Re: Docket No. 465 - The United Illuminating Company Application for a Certificate of Environmental Compatibility and Public Need for the Construction, Maintenance, and Operation of a 115/13.8-kilovolt (kV) Replacement Substation Facility Located on an Approximately 1.5 acre Portion of Two Adjoining UI-owned Parcels Directly Adjacent to UI's Existing Baird Substation, 1770 Stratford Avenue, Stratford, Connecticut, and Related Transmission Structure and Interconnection Improvements.

Enclosed herewith please find the original and fifteen (15) copies of The United Illuminating Company's ("UI") responses to the Siting Council's First Set of Interrogatories dated January 28, 2016 in connection with the above-referenced docket.

Interrogatory CSC-I-1

CSC-I-1 Attachment A - Property Owner Map

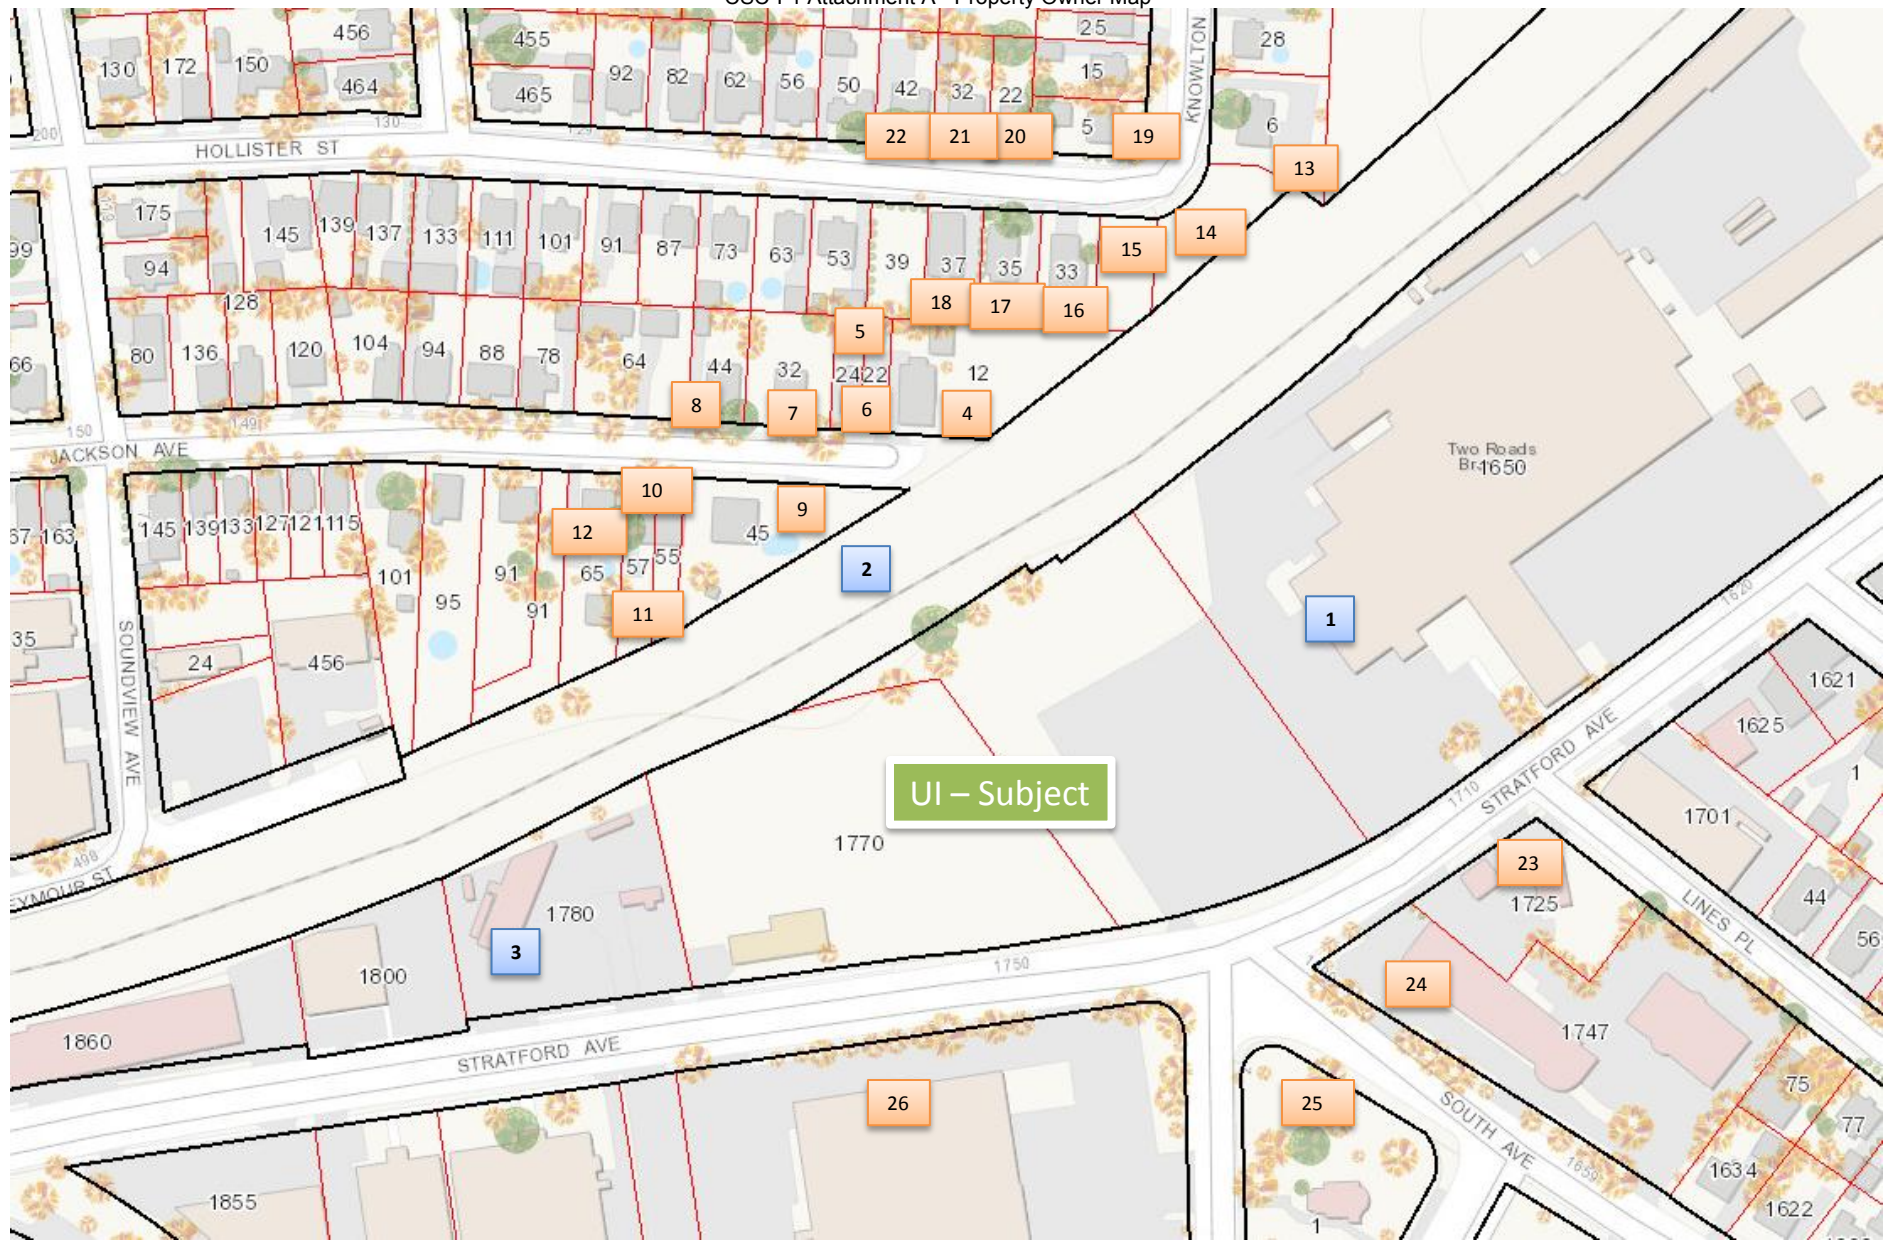
Q-CSC-I-1: Of the letters sent to abutting property owners, how many certified mail receipts were received? If any receipts were not returned, which owners did not receive their notice? Were any additional attempts made to contact those property owners?

A-CSC-I-1: Of the 25 certified mailings to abutting property owners, there were four letters returned unclaimed. Those four letters were resent to the same addresses via regular mail and were not returned. In addition, one certified mail receipt was never returned nor was the corresponding letter. A second letter was sent to the same address via regular mail. The owners that did not receive notice are identified in the attachment referenced below.

See CSC-I-1 Attachment A – Property Owner Map at 1.

CSC-I-3 Attachment B - Map of UI Distribution Service Municipalities

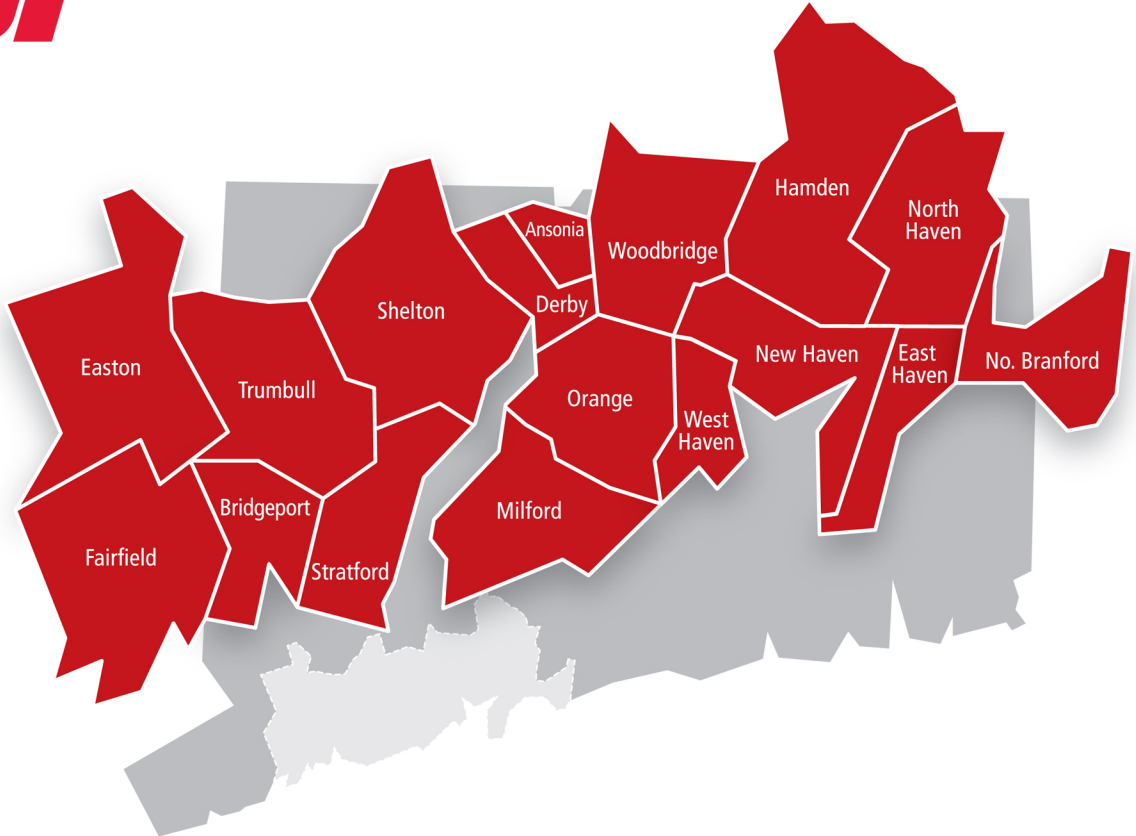
Q-CSC-I-3: Which municipalities make up The United Illuminating Company's (UI) service area for electrical distribution service in Connecticut?

A-CSC-I-3: The following municipalities make up UI's service area for electrical distribution service in Connecticut: Ansonia, Bridgeport, Derby, East Haven, Easton, Fairfield, Hamden, Milford, New Haven, North Branford, North Haven, Orange, Shelton, Stratford, Trumbull, West Haven, and Woodbridge.

See CSC-I-3 Attachment B - Map of UI Distribution Service Municipalities.

PROPOSED SUBSTATION EQUIPMENT AND WETLAND		
CAD FILE NAME	SEQUENCE No.	DRAWING NUMBER
		25253-SK-20160209

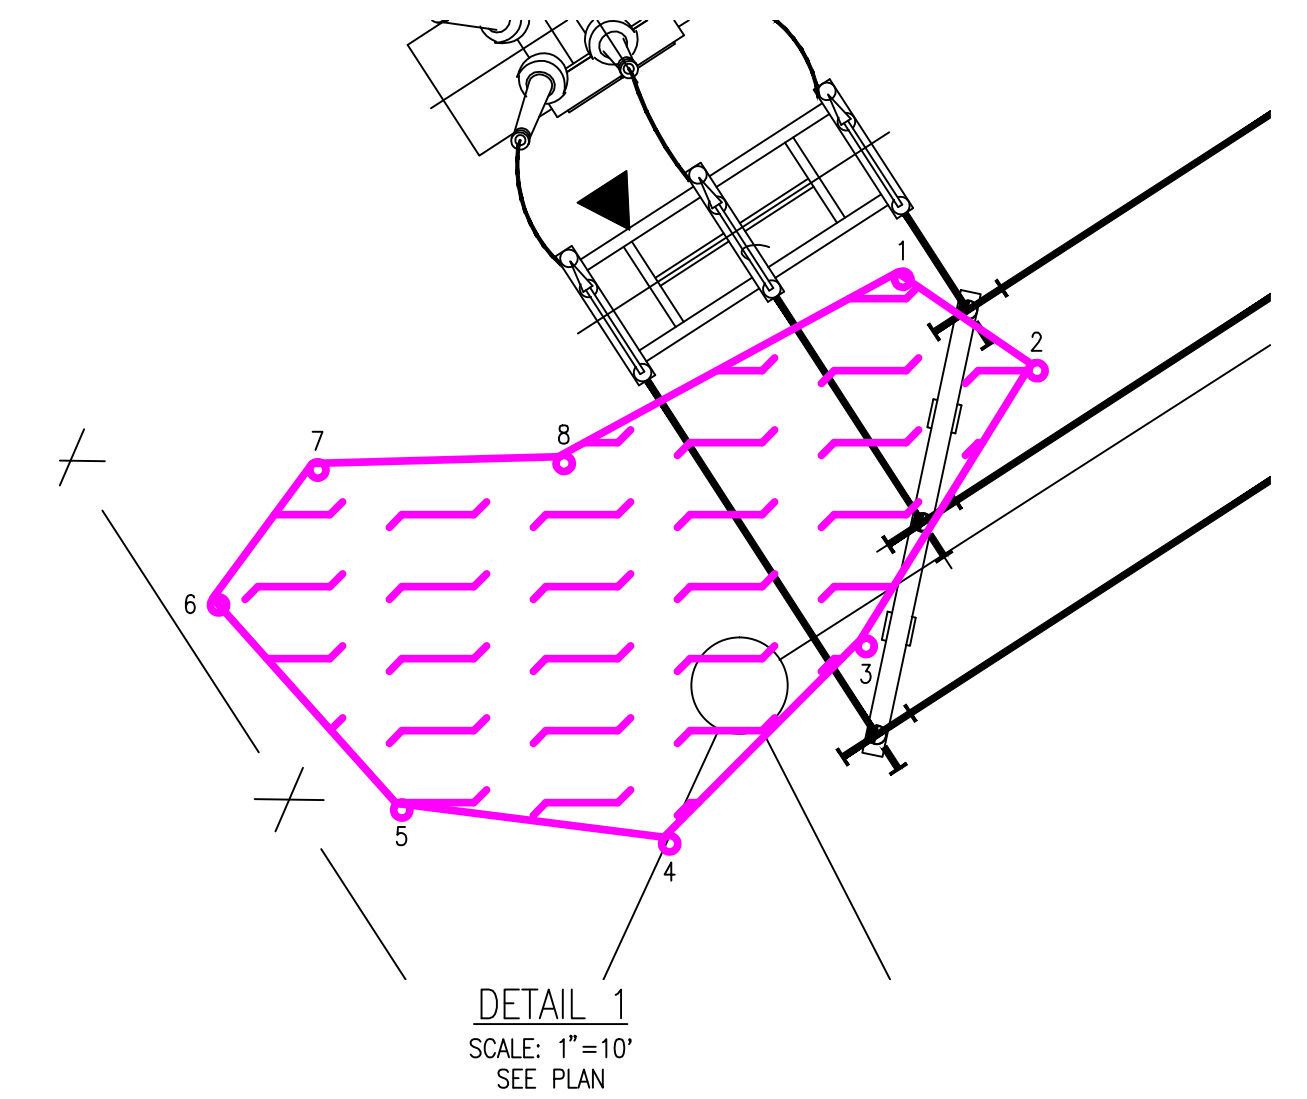
Q-CSC-I-12: Provide the functions and values of the wetland to be filled. Also, provide an aerial view drawing similar to Figure 2 – Delineation Wetland Mapping (behind Appendix C) that depicts both the wetland and the replacement substation equipment in order to demonstrate the proximity of the wetland to the proposed substation equipment.

A-CSC-I-12: See *CSC-I-12 Attachment C – Baird Substation F & V Assessment* regarding the functions and values of the wetland to be filled. An aerial view drawing showing the wetland and proposed substation equipment is shown in *CSC-I-12 Attachment D – Proposed Substation Equipment and Wetland Drawing*.
